## CITY OF AUSTIN Board of Adjustment/Sign Review Board Decision Sheet

То:	Board of Adjustments (BOA)
RE:	SP-2014-0201DS CIG-2014-0137
PROJECT NAME:	6901 #1 Greenshores Drive
Location:	6901 Greenshores Dive
Date Filed:	May 28, 2014
Submittal Date:	July 8, 2014
Date Filed (city by hand):	Aug 21, 2014
Greenshores on Lake Aust	in Homeowner
Name:	Benjamin Janes
Address:	TIT MALIBU COVC
	AUSTN, TEXAS 78730
To the Attention of BOA M	ember
Chair	Jeff Jack
Vice Chair	Melissa Hawthorne
Member	Sallie Burchett
Member	Ricardo De Camps
Member	Stuart Hampton
Member	Vincent Harding
Member	Bryan King
Member	Will Schnier
Member	Michael von Ohlen
Board of Adjustments,  I am am in favor of the Appli	cation, and ask that the Application be allowed:
Existing day dock is	not safe
Existing day dock wa	s built prior to 1980
Proposed day dock is	not good for water quality (constructed with treated wood)
Proposed day dock w	ill be safe (designed to current building codes)
Proposed day dock is	the same width (as existing day dock)

Transmittal		☐ Urgent  ■ As Requested □ For Review and Comment	
		□ FYI	
From:	Bruce S. Aupperle, P.E.	Date: 21Aug14	
To:	City of Austin: Liz Johnston, Rosemary Avila & Andrew Cl

UPPER DECK PLAN | 1"=5"

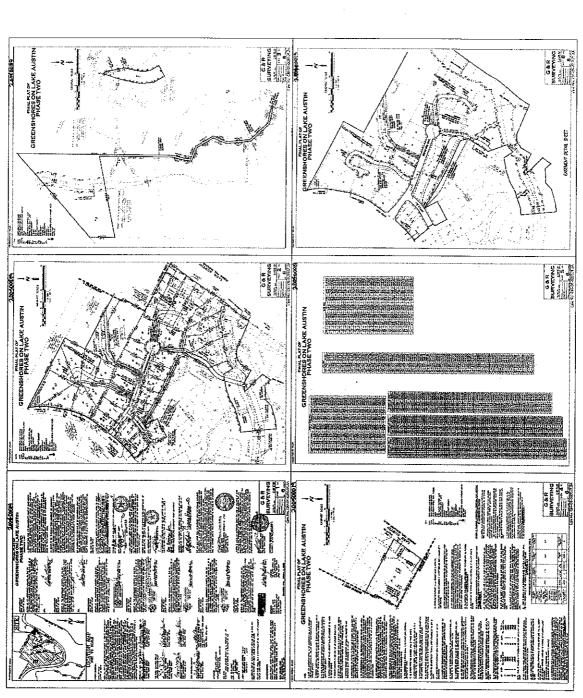
SP12. Please add scale to page 3. Also add dimensions (height) for proposed dock, on page 3. U1: Please use Engineering Scale between 1" = 10' and 1" = 40' and divisible by ten. Please add the height for the proposed dock the elevation profiles.

SP12 Scale is included near north arrow in the upper right quadrant on sheet 3. The height of the dock is included within the detail for Lakeside Elevation in the upper left quadrant of sheet 4.

U2: Comment Cleared.

Lot 25 Existing Shoreline Length = 70'
Existing Dock Width = 39.5' or 56.4%
Allowable Dock Width = 20% of 69.98' = 14'
Proposed Dock Width = 39.5' or 56.4%
Existing Dock Depth = 24.5'
Proposed Dock Depth = 24.5'

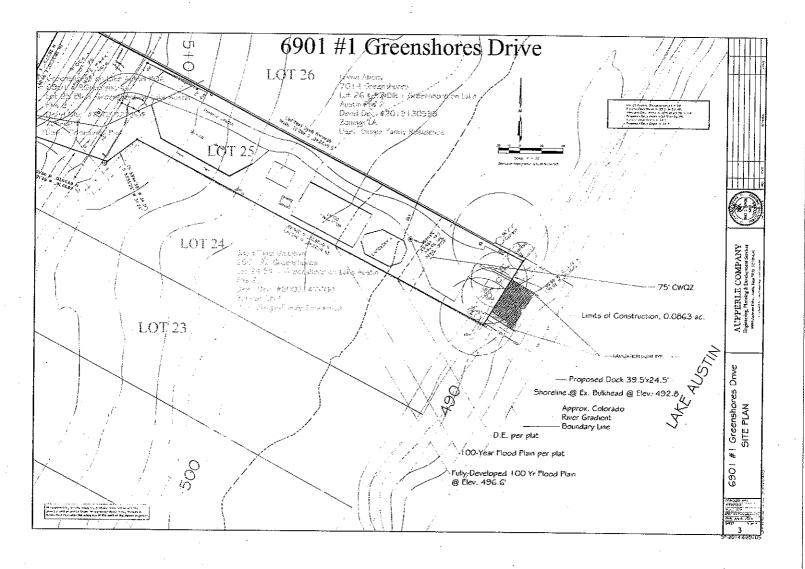
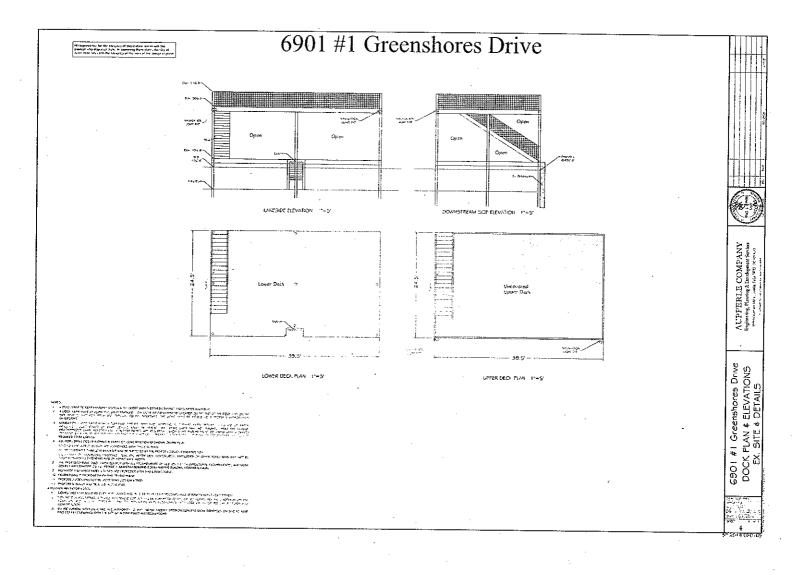
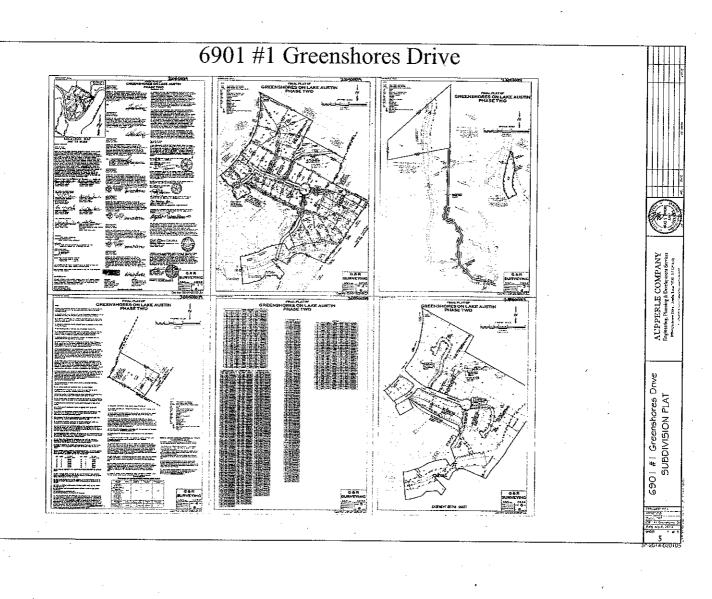
SP2. It appears the proposed swimming dock width exceeds twenty percent (20%) of the length of the shoreline, this must be approved by Planning Commission [LDC 25-2-1176(D)(2)]. Please clarify why the proposed dock is this wide.

- WB1. Update0. It is my understanding that the applicant proposes to construct a dock that exceeds the limit of 20% of the shoreline. A benefit of the 20% rule is that it provides a reasonable use of the aquatic resource without imposing excessive pressure and degradation of the aquatic resource. Shallow water areas are important to the function and quality of the aquatic resource. Excessive construction of structures which block both sunlight and allochthonous inputs limit the ability for plants, fish and wildlife to function properly. A variance may be required for the proposal. This reviewer does not support the proposed increased impacts to the shore, near shore and shallow water area.

- WB1. Update1. COMMENT NOT ADDRESSED. REPEAT COMMENT. Proposed dock increases impact to shoreline and near shore area by effectively doubling the footprint. The limitation on structure size and extent is designed to support reasonable use of the lake while supporting beneficial chemical and biological function of the shoreline. As stated in UO, A variance may be required for the proposal. This reviewer does not support the proposed increased impacts to the shore, near shore and shallow water area. Please revise accordingly.

- WB1. Update2. COMMENT NOT ADDRESSED. REPEAT COMMENT. Applicant asserts that the proposed dock will not no "wider or deeper" than the existing dock, however, it is clear that the dock will double the footprint and impact a much larger portion of the lake and shoreline. This reviewer does not support the proposed increased impacts to the shore, near shore and shallow water area. Please revise accordingly.

SP2 The new dock will be no wider or deeper than the existing dock, yet the dock will exceed 20% of the shoreline width as noted on plans and in engineer's summary. We understand that BOA approval is required now for this variance.

WB The new dock will be no wider or deeper than the existing dock, nor will the shoreline be modified. Your non-support of the variance to maintain the existing dock footprint is noted.

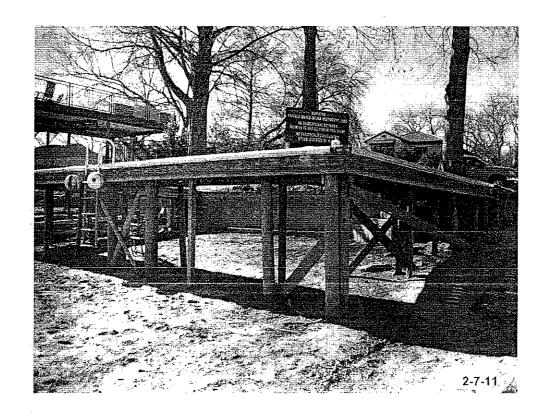
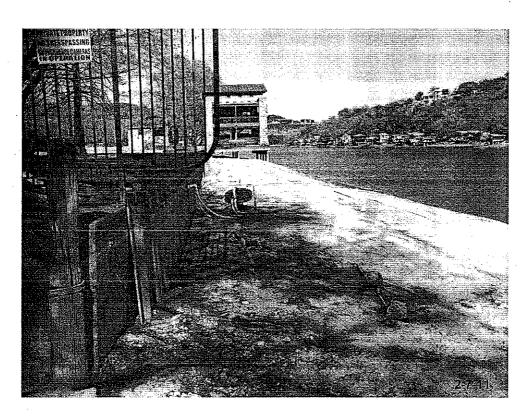
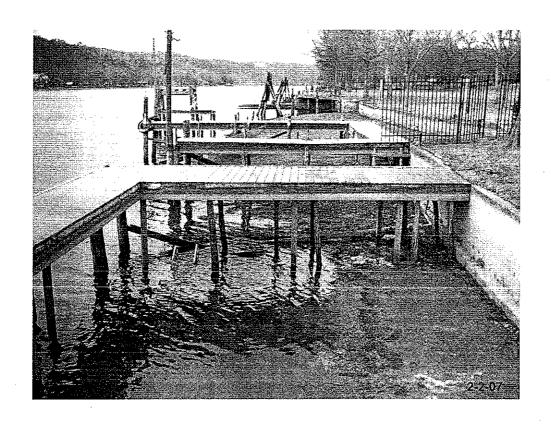
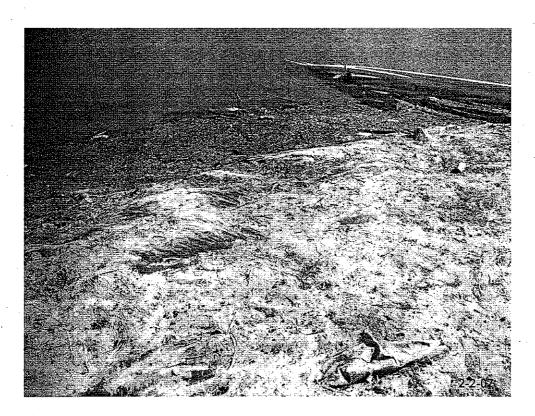
- 1. Excessive construction of structures which block both sunlight and allochthonous inputs limit the ability for plants, fish and wildlife to function properly.
- 2. This reviewer does not support the proposed increased impacts to the shore, near shore and shallow water area.
- 3. A liner does not prevent plant growth, it only hinders/slows progress of certain plants, and therefore is not a reason to support t the proposed permanent structure. Sago pondweed and several other beneficial and innocuous plants and animals are able to exist over liners as sediment builds up and liners break down.
- 4. The proposed doubling of the proposed structure footprint shall further degrade available habitat and shoreline.

Please review the enclosed photographs that I took in 2007 and 2011. They illustrate that:

- 1. There is a liner under and around the existing dock.
- 2. There is not any plant growth in or around the existing dock over the course of four years. Note that the debris in the photos is cypress needles and other material that is not rooted in the soil.
- 3. There are no plants in the exposed shore areas areas with and without docks. Look at the exposed shore areas of the lake that have no docks, and you will notice that there is no plant debris.

The photographic evidence contradicts Wetlands Biologist Andrew Clamann's assertion that plants can grow over liners. The photos reveal that docks, at least the Association's dock, does not limit the ability of plants, fish and wildlife to function properly. That being the case, removing the existing dock and building a new dock with the same footprint will have no impact on plants and fish.
